# Access Compliance Report

## Public Rights-of-Way

### (Curb Ramps)

Intersection ID: 10042346	Main Street: WRANGELL_LN	Cross Street: N/A	Location: E
ADA ID: F3DEF9E63A77	Ramp Type: BlendTrans1	Initial Pass/Fail: Fail	Overall Compliance: No
		Severity Score: 10

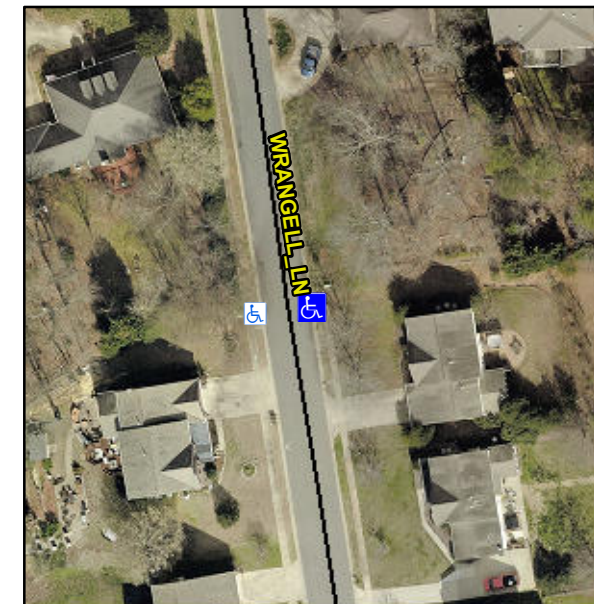
Surveyor Notes:

**NO LT SW**

PROW/ADA:

**Not Found, R304.5.1, R304.5.3**

Possible Solutions:

**Remove & Replace Curb Ramp With Two New Directional Ramps or Equivalent.**
